NOTICE OF PROPOSED CHANGE IN PROPERTY

Petition: x1822

DTE Energy
(Utility or City Department)

REQUEST ENCROACHMENT
 INTO VARIOUS LOCATIONS
 IN THE AREA BOUND BY
 ST. JEAN, FREUD, ST. CLAIR
 AND E. JEFFERSON AVE.
 (With Sub-Surfacing Management System)

| DRWG. NO. | X 1822 |

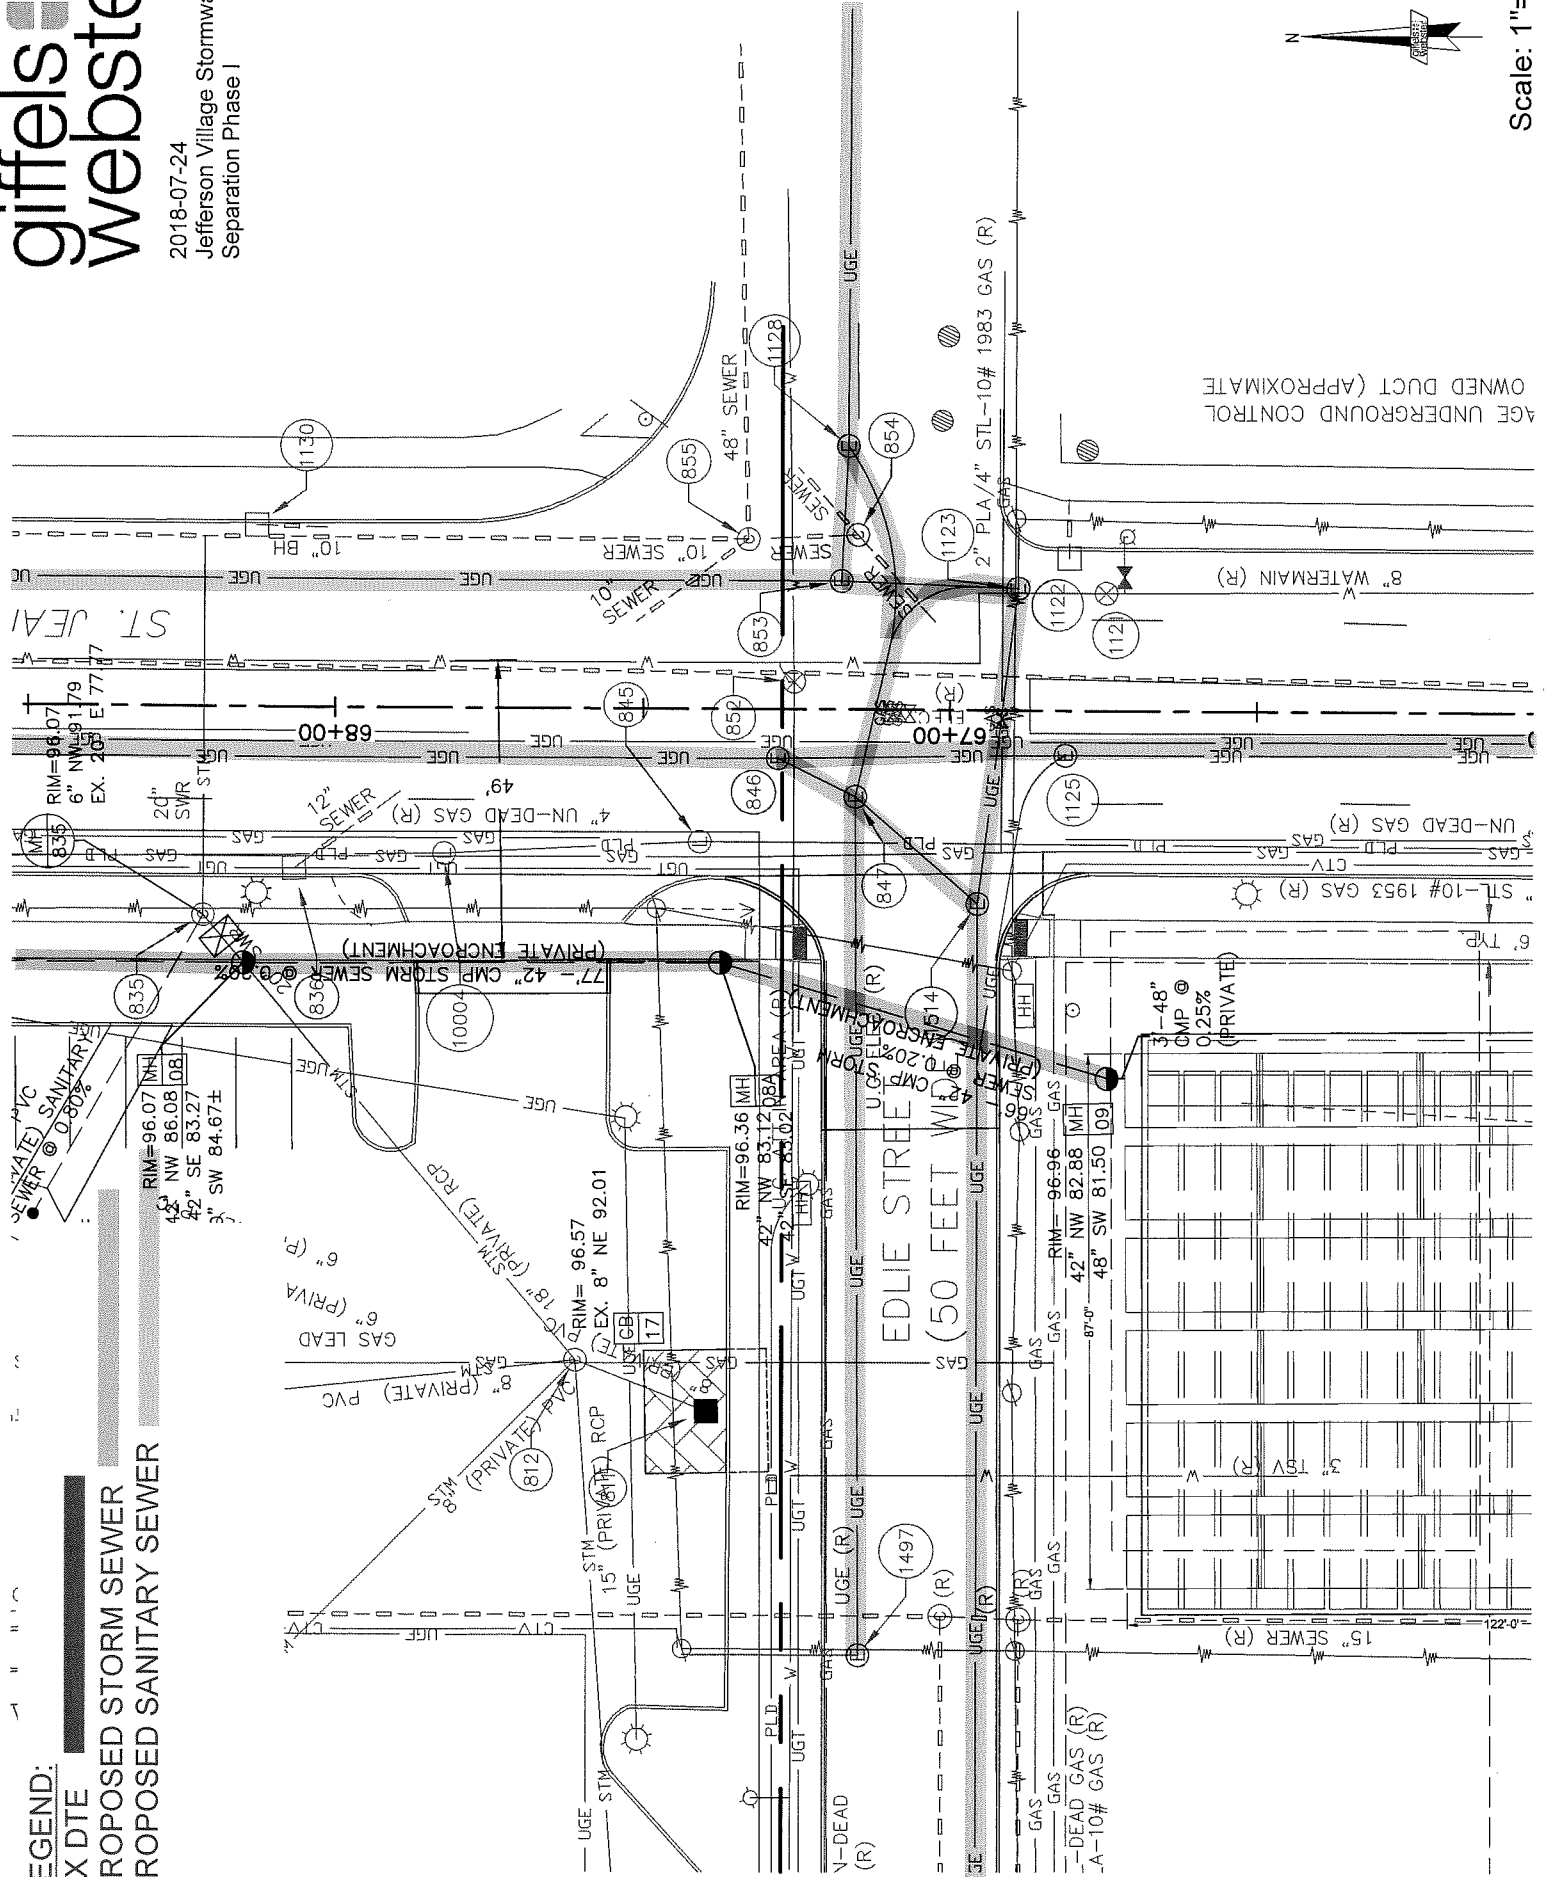
\$1,800.95 - To have DTE Energy tech out on site (St. Jean Ave. & Edlie Ave.) for two days to monitor open dig around DTE conduit, ~~LOC II~~ LOC II. All other locations are clear.

15' wide?
 13' deep. } @ Station & Eddie
 - There is a pole @ corner of St Jean
 & Eddie that would have to be
 relocated. Shallowest depth would be
 to look above this crossing
 120 FT. WD.
 Other pipe crossings @ 5' wide
